Subject: Former Mabardy Landfill, Winchendon, MA
Request to Amend the Order of Conditions
MassDEP File No. 345-0675
CEC Project 306-000

On behalf of 580 River Street LLC (the Applicant), Civil & Environmental Consultants, Inc. (CEC) is pleased to submit this Request to Amend the Order of Conditions (MassDEP File # 345-0675) with supporting information for the final closure of the former Mabardy Landfill located on River Street (Map 17 - Lot 42 and Map 17 – Lot 41) in Winchendon, Massachusetts (Site). This Request to Amend the Order of Conditions is submitted in accordance with the Massachusetts Wetlands Program Policy 85-4: Amended Orders and in accordance with Condition numbers 14 and 29 from the Order of Conditions that was issued for the project.

The Applicant submits this Request to Amend the Order of Conditions to incorporate modifications to the north stormwater basin design based on test pits performed upon commencement of the site work which revealed existing groundwater conditions were different than originally assumed in the design. Condition number 27 of the Order of Conditions that was issued for the project required that test pit investigations be performed within th

DRAWING NO. **C301**
 SHEET 4 OF 5

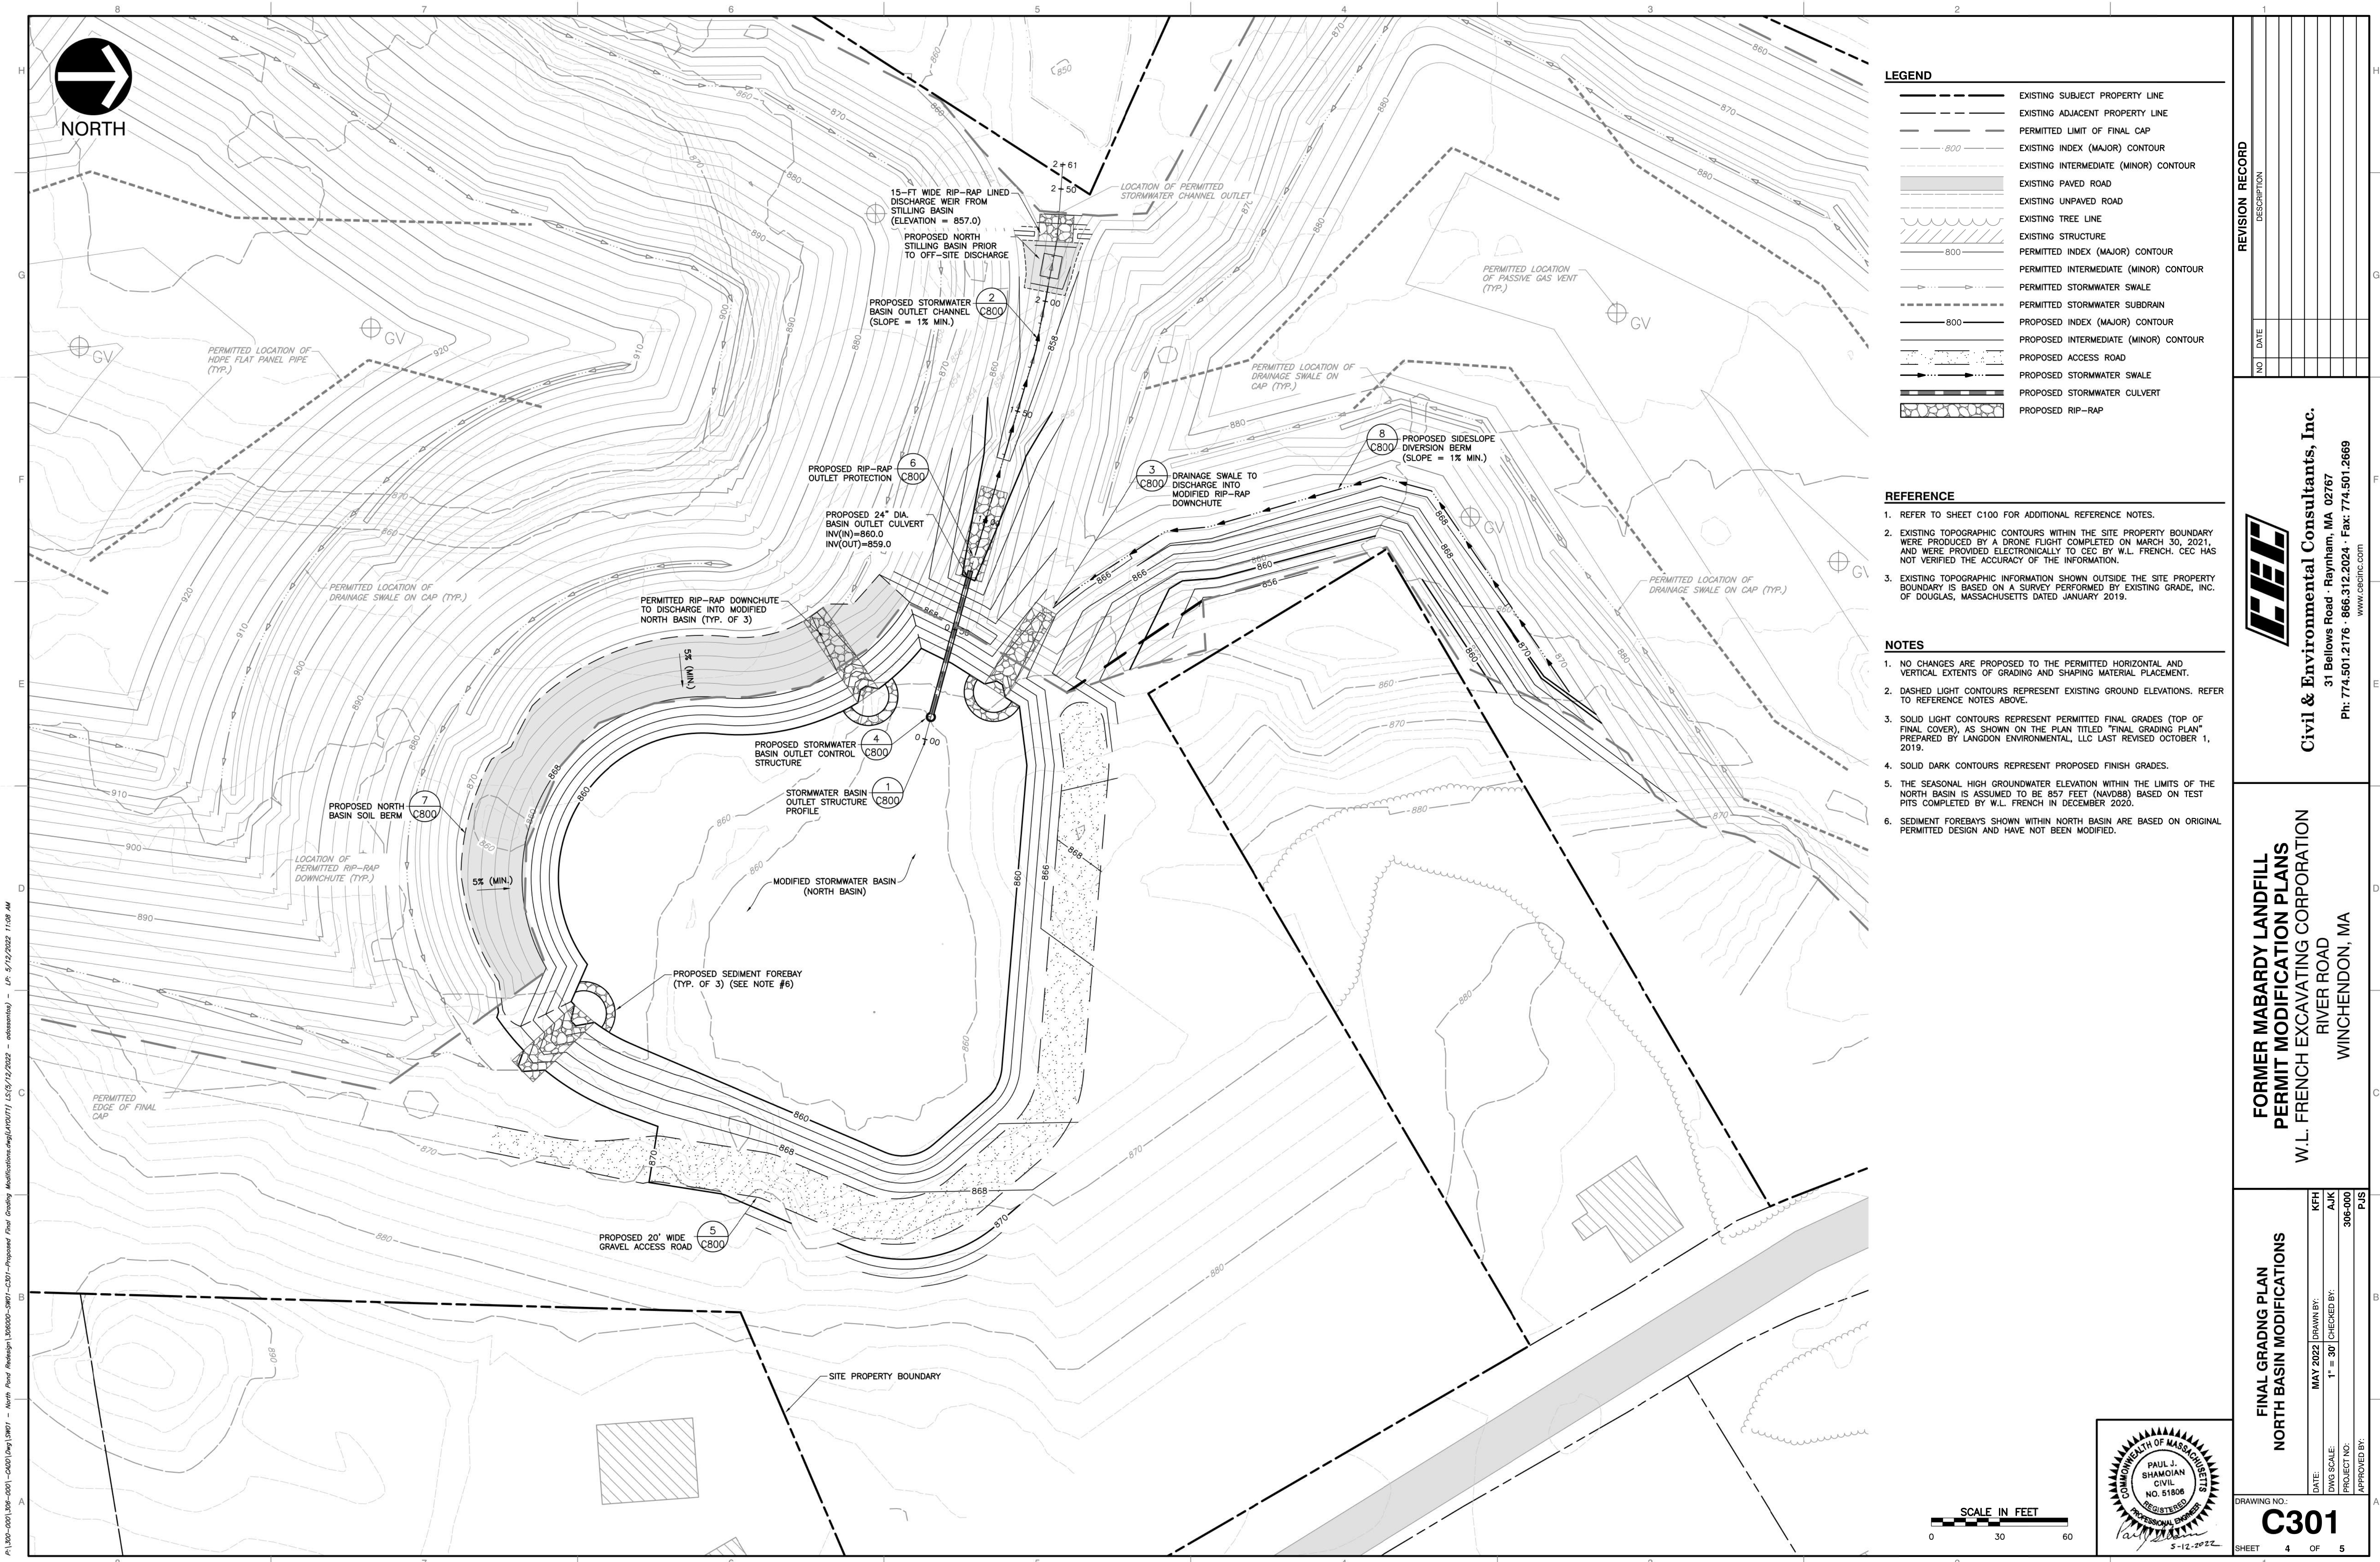
The previous design of the north basin provided sufficient depth such that stormwater collected within the basin was below the lowest elevation of the nearby edge of final cap. As a result of the base elevation of the north basin being raised under the proposed modifications, stormwater collected in the basin is at or above the elevation of the edge of nearby final cap. To prevent stormwater from ponding against the landfill final cap, the proposed modifications include the construction of a soil berm along the southern and western perimeter sides of the basin. The soil berm provides horizontal separation between the basin and the landfill to prevent the ponding of stormwater above and/or against the final cap.

As part of this design modification, an additional stilling basin is proposed to be added along the western limit of the property. Outflow from the north basin outlet channel will be directed to this stilling basin prior to discharging off-site. This basin will provide additional attenuation of peak flow prior to discharging off site, while also allowing an additional sedimentation settling area. The outlet for this stilling basin is a rip-rap weir that will discharge to the currently permitted outlet discharge location. Based on original test pits conducted as part of the original Corrective Action Design (CAD) Application, there appears to be no solid waste in the location of this additional stilling basin. However, the limit of final cover geosynthetics within this area is proposed to remain unchanged along the western limit of the Facility for continuity of the final cover system, and the basin will be constructed within the final cover system

4 C800
STORMWATER BASIN OUTLET CONTROL STRUCTURE
 SCALE: NOT TO SCALE

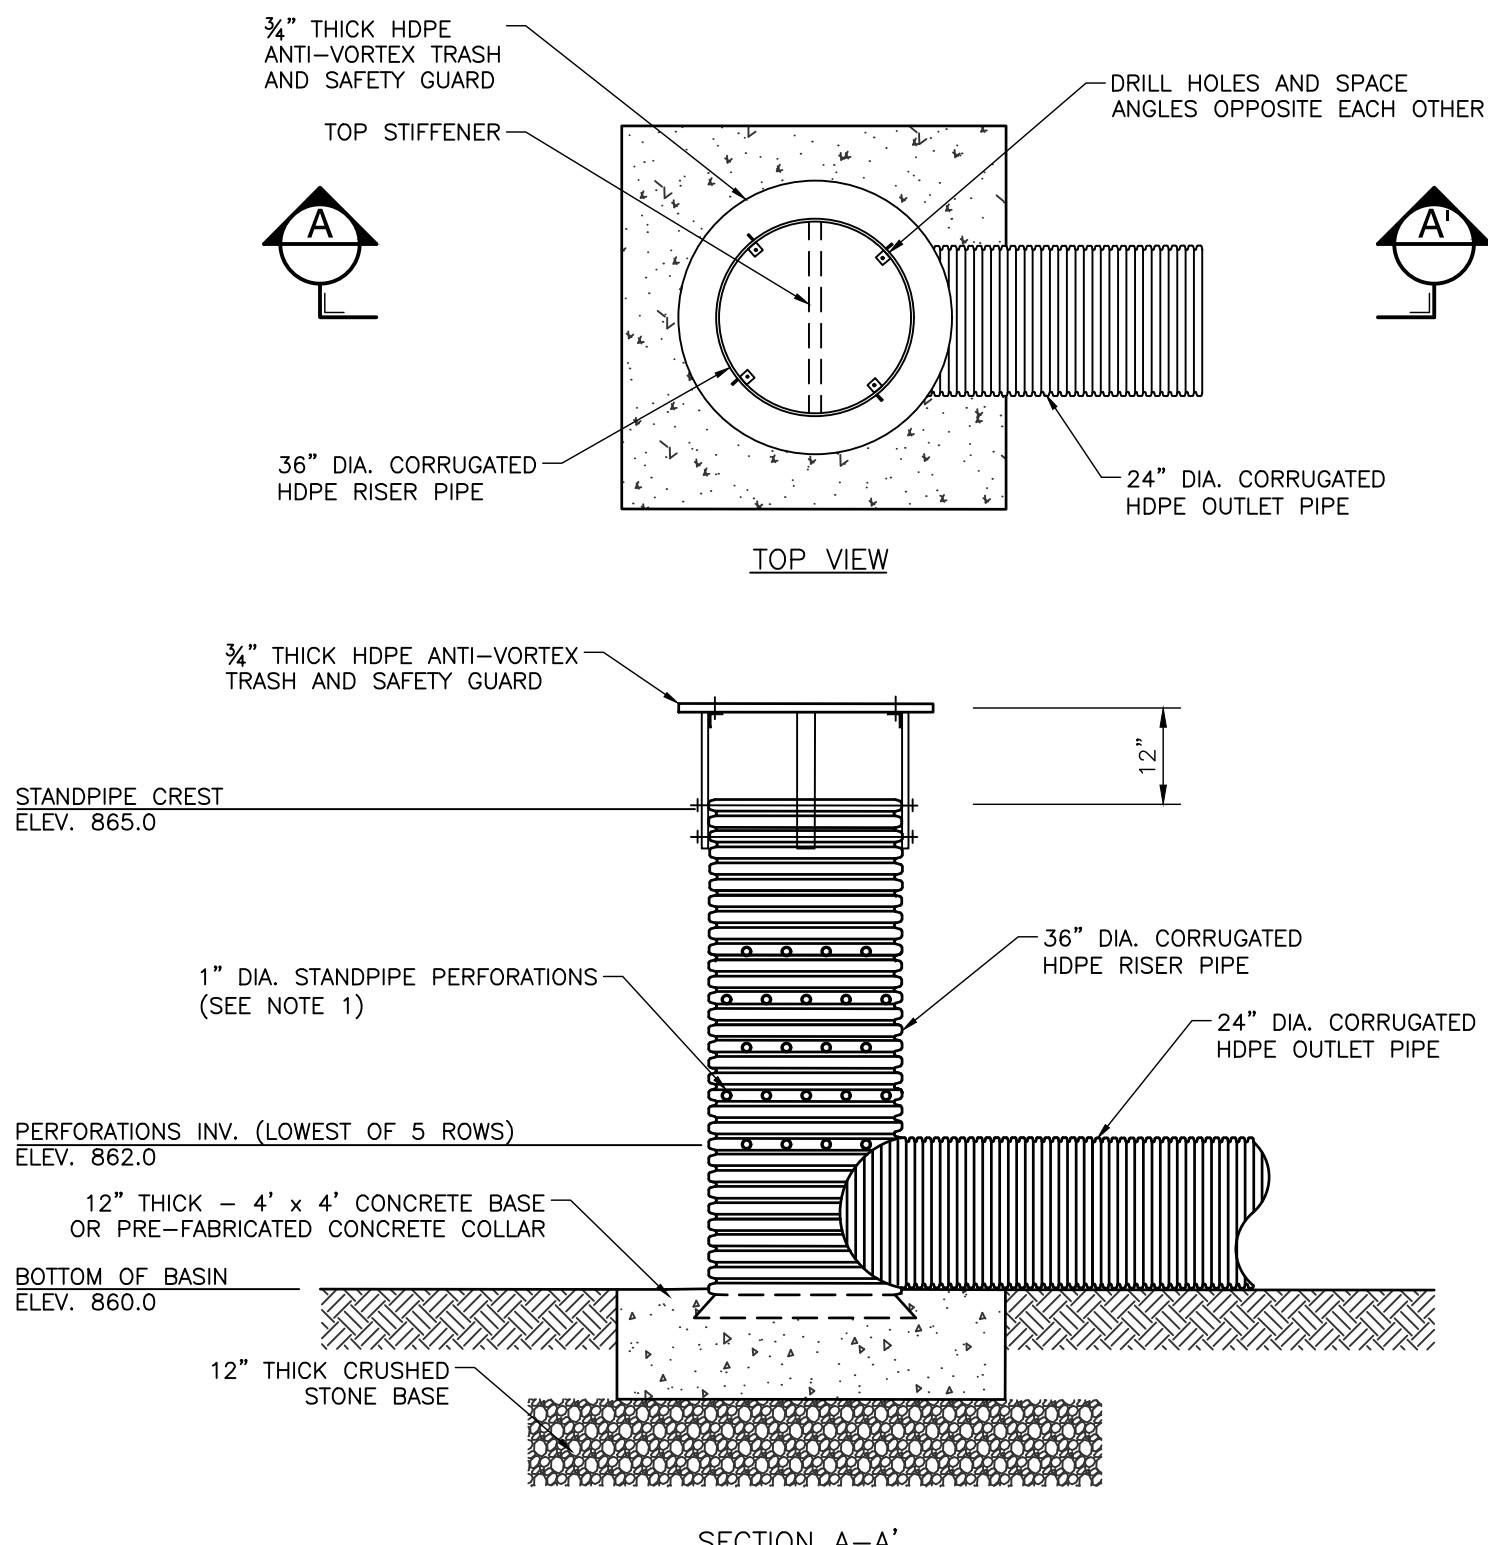
The outlet control structure proposed for the modified north basin has been altered from the permitted design. The permitted outlet structure consisted of a concrete V-notch weir with an invert elevation of 853.75 feet. The proposed outlet structure consists of a vertical HDPE perforated standpipe with a single 24-inch diameter corrugated HDPE outlet culvert. The proposed standpipe is 36-inch diameter HDPE with five rows of 1-inch diameter perforations evenly spaced around the circumference of the standpipe. The invert of the lowest row of perforations is at elevation 862 feet. Stormwater will be conveyed through the 24-inch diameter corrugated HDPE outlet culvert to a stormwater outlet channel. The outlet channel will discharge stormwater into a new stilling basin, which will then discharge off-site to the wetlands located to the west of the
